Access Compliance Report

Public Rights-of-Way

(Curb Ramps)

Intersection ID: 3923	Main Street: BRIGHTLEAF_PL	Cross Street: COBBLE_GLEN_WY	Location:	E
ADA ID: 5677968A4051	Ramp Type: BlendTrans1	Initial Pass/Fail: Fail	Overall Compliance: No	Severity Score: 1.25
Codes/Mitigation Info/Possible Solution		Field Measurements/Component Compliance

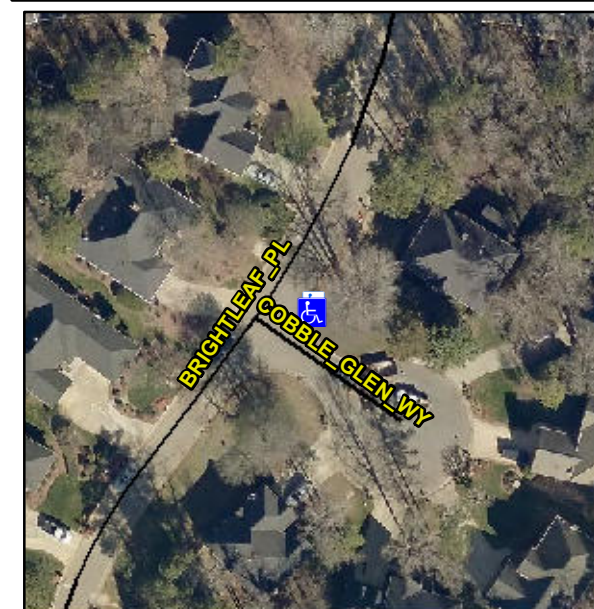
PROW/ADA:

Not Found, R304.5.3

Compliance	Description	Data	Compliance	Description	Data
N/A	Ramp Length (in)	27.0	Yes	BlendTrans Slope (%)	4.6
Yes	Ramp Width (in)	48.0	No	BlendTrans XSlope (%)	2.4
N/A	Flare Type LT	Sloped	N/A	Flare Type RT	Sloped
N/A	Flare Slope LT (%)	3.6	N/A	Flare Slope RT (%)	11.6
N/A	Flare Traversable LT?	No	N/A	Flare Traversable RT?	No
N/A	Landing Length (in)	57.0	N/A	DWS Provided?	Yes
N/A	Landing Width (in)	47.0	N/A	DWS Contrast?	Yes
N/A	Landing Slope (%)	1.7	N/A	DWS Length (in)	24.0
N/A	Landing X Slope (%)	1.1	N/A	DWS Full Width?	No
N/A	Landing Curb? (Y/N)	No	N/A	DWS Offset (in)	N/A
N/A	Shared Landing?	No			
N/A	Gutter Ponding?	Yes	N/A	Gutter Slope (%)	2.2
N/A	Gutter Lip Ht (in)	0.0	N/A	Gutter X Slope (%)	0.0
N/A	Painted X Walk1?	No	N/A	Painted X Walk2?	N/A
	X Walk 1 Direction	To SW		X Walk 2 Direction	N/A
	X Walk 1 Width (in)	N/A		X Walk 2 Width (in)	N/A
	X Walk 1 Slope (%)	3.6		X Walk 2 Slope (%)	N/A
	X Walk 1 X Slope (%)	1.2		X Walk 2 X Slope (%)	N/A

N/A	Ramp inside XWalk1?	N/A	N/A	Ramp inside XWalk2?	N/A
	Road Slope (%)	1.2		Clear Space?	Yes
	Road X Slope (%)	3.6	N/A	Clear Space to XWalk (in)	N/A
N/A	Any Obstructions?	No	N/A	Storm Grate/Utility Hazard?	No
	Obstruction Type			Storm Grate/Utility Type	
		N/A			N/A
		Yes		Surface Condition? (G/P)	Good
		No		Curb Slope (%)	16.2

Possible Solutions:

Remove & Replace Curb Ramp With Two New Directional Ramps or Equivalent.
